CORRIGENDUM - I

Tender Notification No.: 24SP022T dated: 18.04.2024

Notice Inviting Tender for the Supply, Installation, Testing and Commissioning of HVAC works (in Fifth and Sixth floor) at Chennai Campus of IIM Tiruchirappalli.

Corrigendum/Amendments in the tender document

FIFTH & SIXTH AC FLOOR LAYOUT

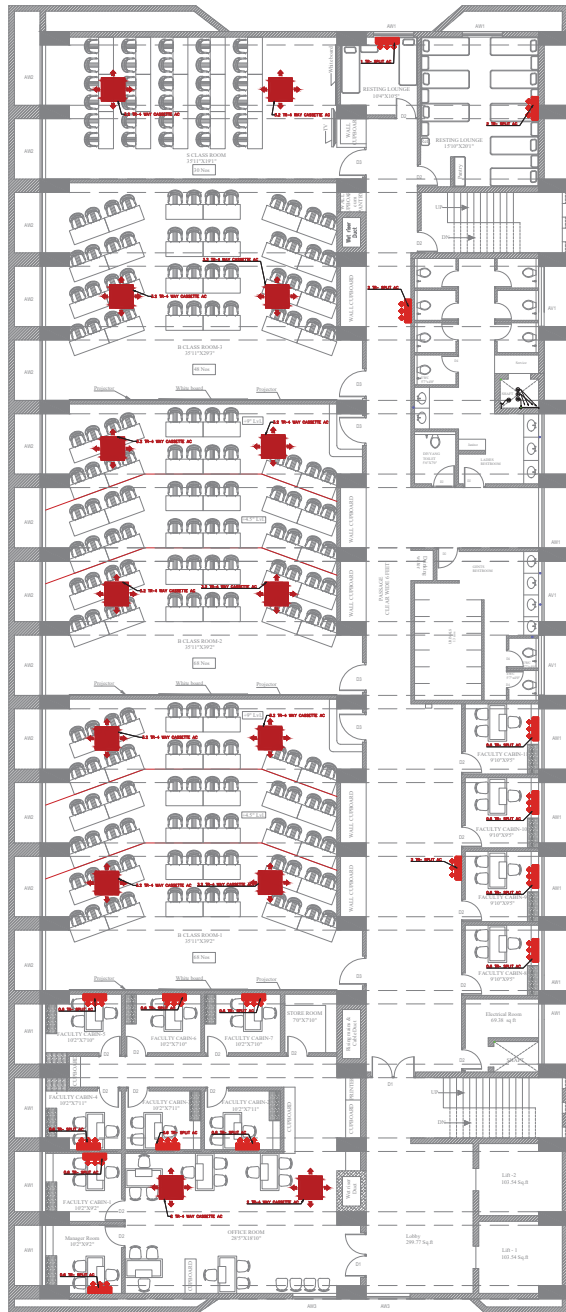
S. No	Reference to the Tender	Amendments
1	Page No. 24 -26 of the main tender Document i.e. Annexure –II.	Page Number 24-26 stands cancelled, and Revised Annexure – II (Price Bid – BoQ) is incorporated from Page 4 of this Corrigendum. Hence, the bidder should quote their rate only in the Revised Price Bid as available in this Corrigendum – I and the same has to be placed in Price Bid Cover(i.e. Cover 2).
2	Indoor AC Layout is attached for the reference of the bidders under this corrigendum.
